Technical change to FieldPower® (GHDE)

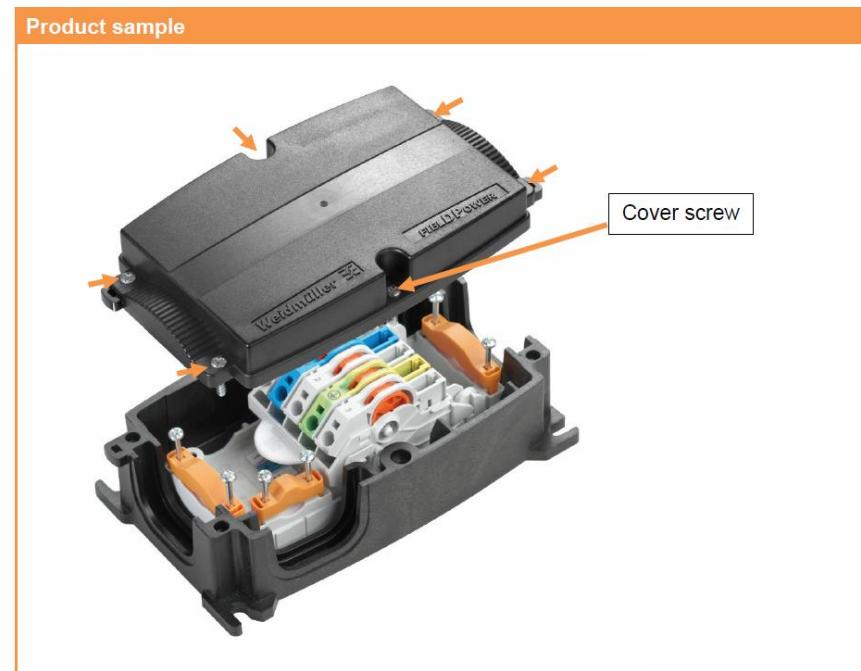
The screws for fastening the cover are changed in terms of drive and material.

Old: PZ2 - galvanized

New: TX20 – stainless steel V2A
